ACCURACY GUN

ALTERNATE AH-1 DESIGN

ADD TO A0820-94

SHEET NO M-1A

PARTIAL ROOF PLAN

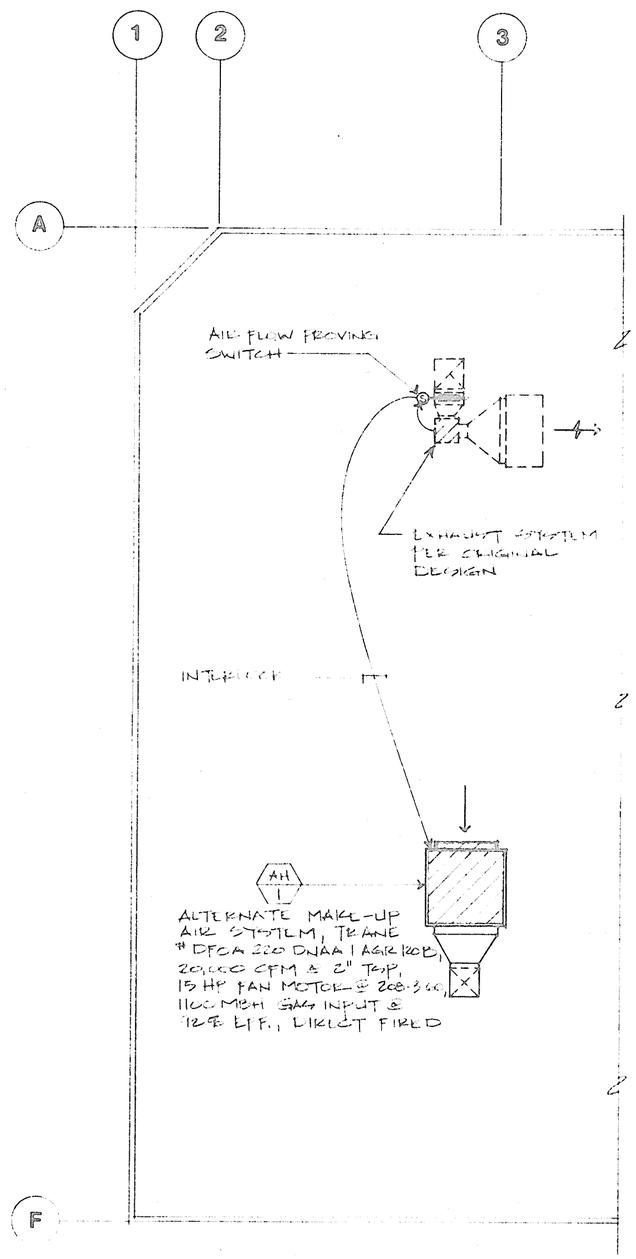
1. The effects of this alternate design upon the mechanical scope of work are listed as follows:
   - a. The original design utilized a rooftop air handling unit (AH-1) containing a hot water heating coil, boiler (B-1), pump and circulation piping to provide make-up air to the gun range.

- b. The alternate design will instead utilize a packaged rooftop direct gas fired air handling unit (AH-1) to provide make-up air to the gun range.

- b. MECH-1 Part 2 of 3(Certificate of Compliance) Previous system (B-1) omitted, system AH-1 revised. See attached supplemental form
   - c. MECH-1 Part 3 of 3(Certificate of Compliance) ignore reference to Pipe Insulation, boiler and piping omitted.
